April 30, 2012

Re: Comments on the Sunday Mine (M/1977/285) Bond Recalculation Estimate.

Photo 1.

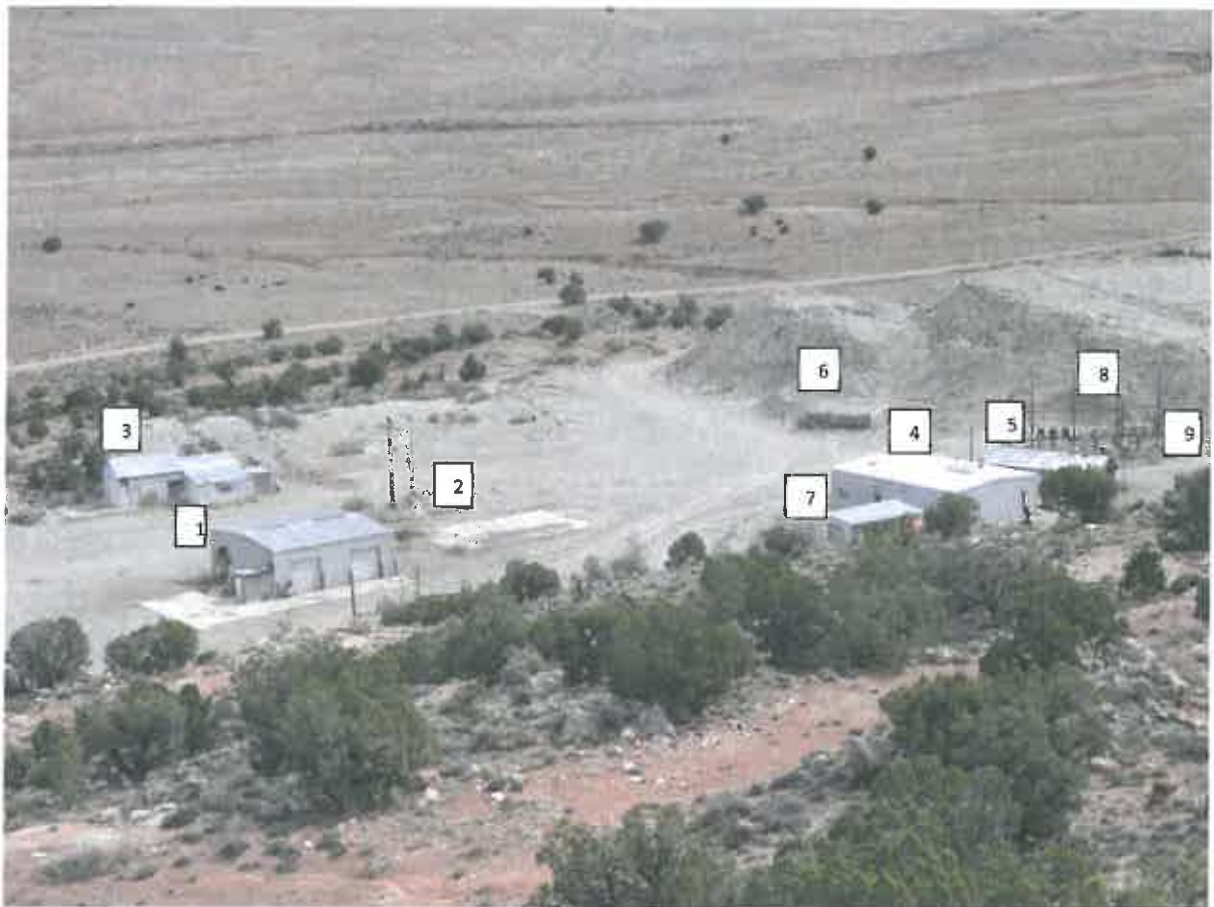
The first photograph (Photo 1) is an overall view of the Sunday Mine yard from the ridge above the mine. The buildings and facilities in the photo are labeled for reference in the following discussions.

1. Sunday West Main shop and adjacent wash pad.
2. Location of Tire shop and Warehouse building that has been removed. Only slab remaining.
3. Ambulance Shed and Warehouse.
4. Sunday Main Dry Room.
5. Old Compressor shed.
6. Fuel Storage area with tanks removed.
7. Small Warehouse for drill supplies.
8. Transformer Station.
9. Compressor building removed – slab remaining.
